**80/363/NP****NEW WORK ITEM PROPOSAL**

IEC/PAS 61162-101: Maritime navigation and radiocommunication equipment and systems - Digital interfaces - Part 101: Single talker and multiple listeners - Modified sentences and requirements for IEC 61162-1

**MARITIME NAVIGATION AND RADIOCOMMUNICATION EQUIPMENT AND
SYSTEMS-DIGITAL INTERFACES-****Part 101: Single talker and multiple listeners-
Modified sentences and requirements for IEC 61162-1**

5.3 ALR – Set Alarm State

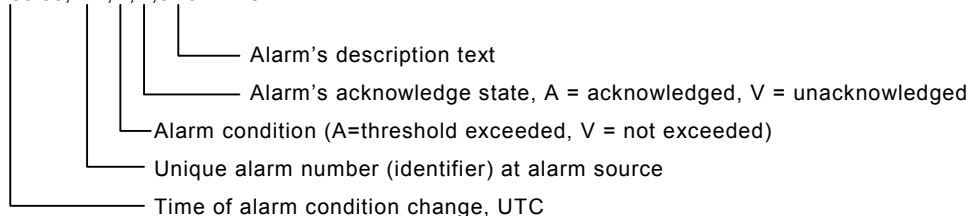
Updated the text label of the alarm identification field to be the same as that field in the ACK sentence.

\$--ALR,hhmmss.ss,xxx,A,A,c--c*hh<CR><LF>

5.12 GST – GNSS pseudorange noise statistics

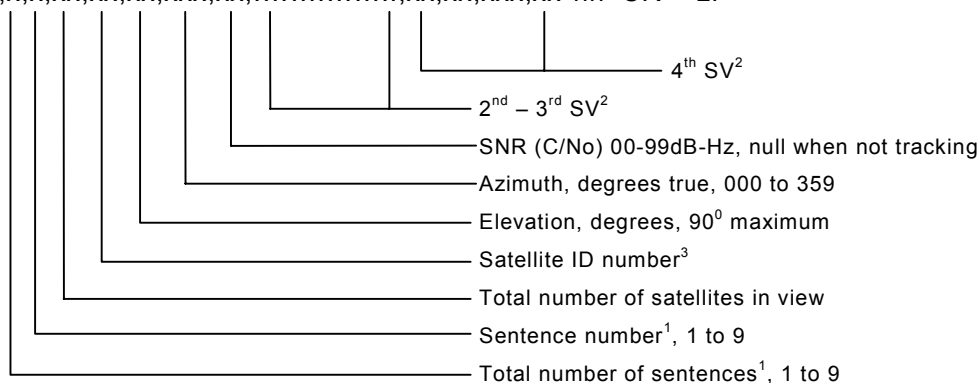
Amend the word “message” in the opening paragraph to “sentence”.

5.21 XDR - Transducer Measurements

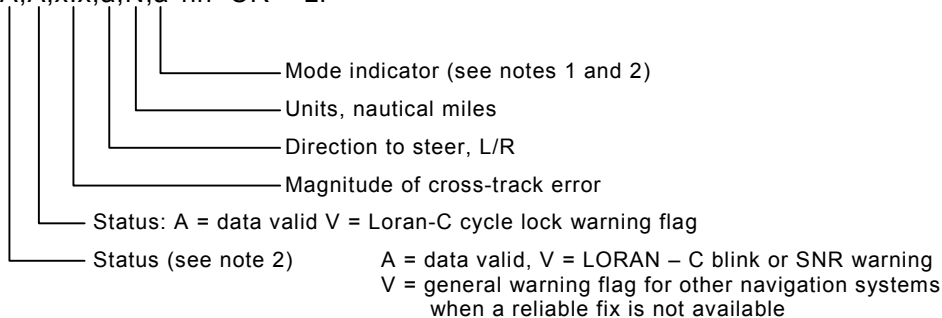
An additional transducer type has been added to the XDR sentence to support salinity measurements.

Add the unit definition to Table 3 of 61162-1 – Character symbol table

Transducer	Type Field	Units Field	Comments
Salinity	L	S = ppt	ppt = parts per thousand
Absolute humidity	B	K = kg/m ³	kilograms per cubic metre

K Kilometers; km/hr; kg/m³

5.22 XTE –correction

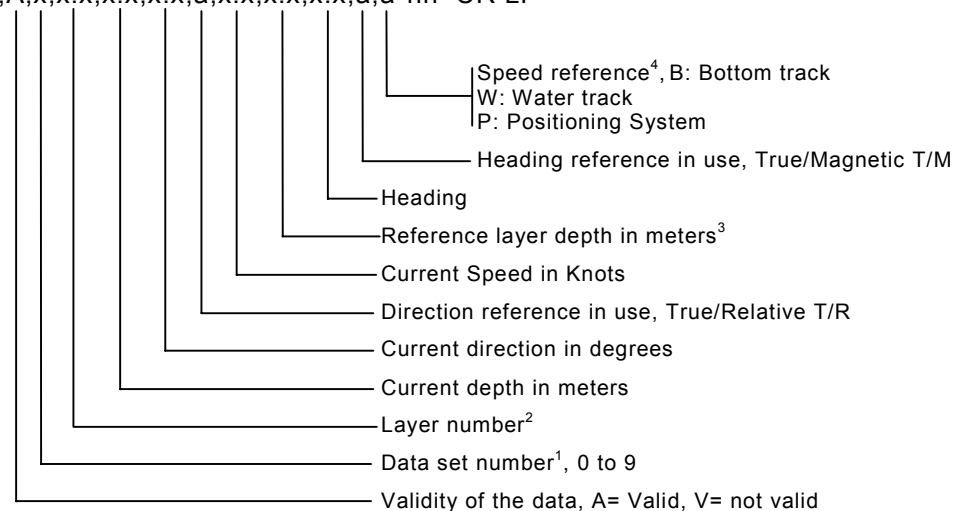
In Edition 2 of IEC 61162-1 there was a printing / format error in this sentence. The correct definition is given below.

\$--XTE,A,A,x.x,a,N,a*hh<CR><LF

A = Autonomous mode
D = Differential mode
E = Estimated (dead reckoning) mode
M = Manual input mode
S = Simulator mode
N = Data not valid

NOTE 2 The positioning system Mode indicator field supplements the positioning system Status fields (fields No. 1 and No.2); the status fields shall be set to V = invalid for all values of indicator Mode except for A = Autonomous and D = Differential. The positioning system Mode indicator and Status fields shall not be null fields.

6.2 GMP -GNSS Map Projection Fix Data

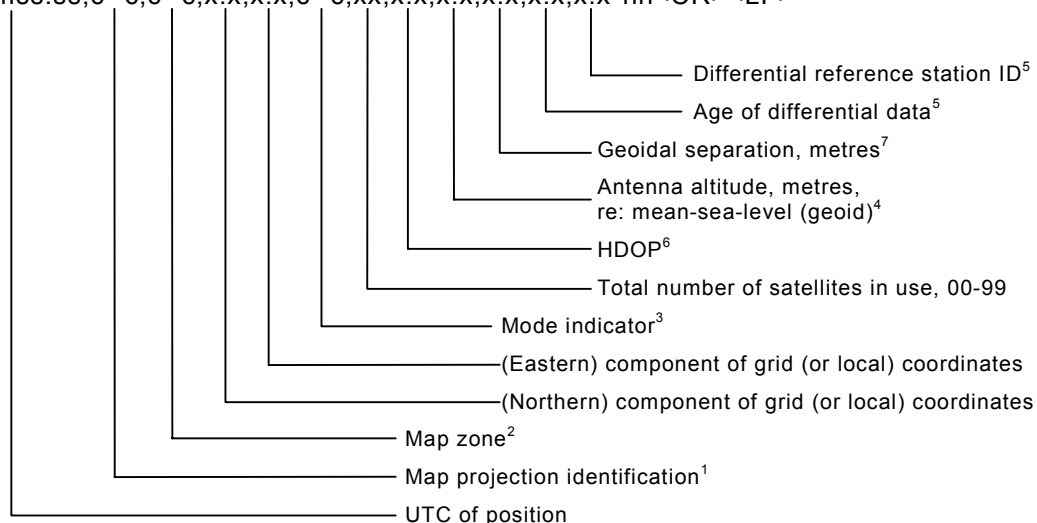
This new sentence has been created to support land use and provide map projection co-ordinates of any GNSS system.

\$--GMP,hhmmss.ss,c--c,c--c,x.x,x.x,c--c,xx,x.x,x.x,x.x,x.x,x.x*hh<CR><LF>

6.4 MWV - Wind Speed and Angle

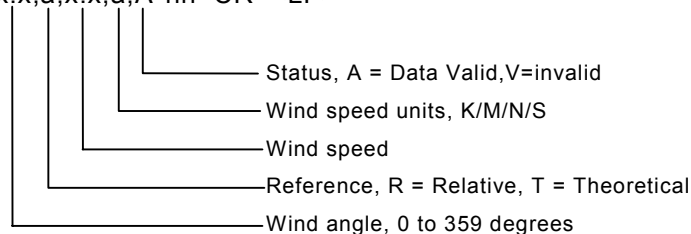
A new description has been added to the MWV sentence. This description attempts to clarify the use of this sentence, and describes the differences between apparent and true wind.

\$--MWV,x,x,a,x,x,a,A*hh<CR><LF>

6.5 TUT – Transmission of multi-language text

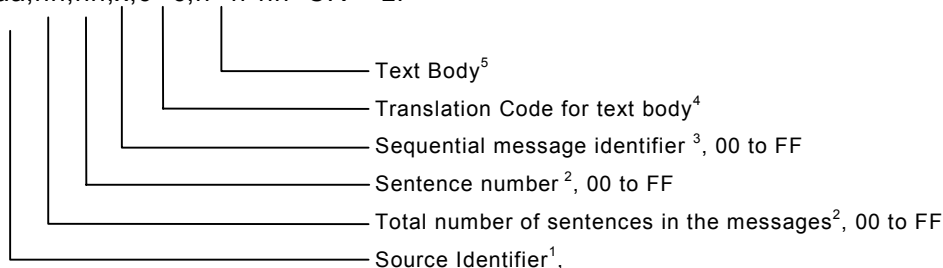
A new sentence created to support multi-language text. This is the first time that a variable length Hex field has been used in a sentence definition.

The sentence structure is similar to the TXT sentence, however it has two additional fields. There is a "Source identifier" field used to identify the origin of the sentence and a "Translation Code" field that is used to define the coding system for the text body. This enables the use of multi-language codes, such as, Unicode or other codes. A proprietary look-up table method is incorporated to allow pre-defined messages to be sent in short sentences.

\$--TUT,aa,hh,hh,x,c--c,h--h*hh<CR><LF>
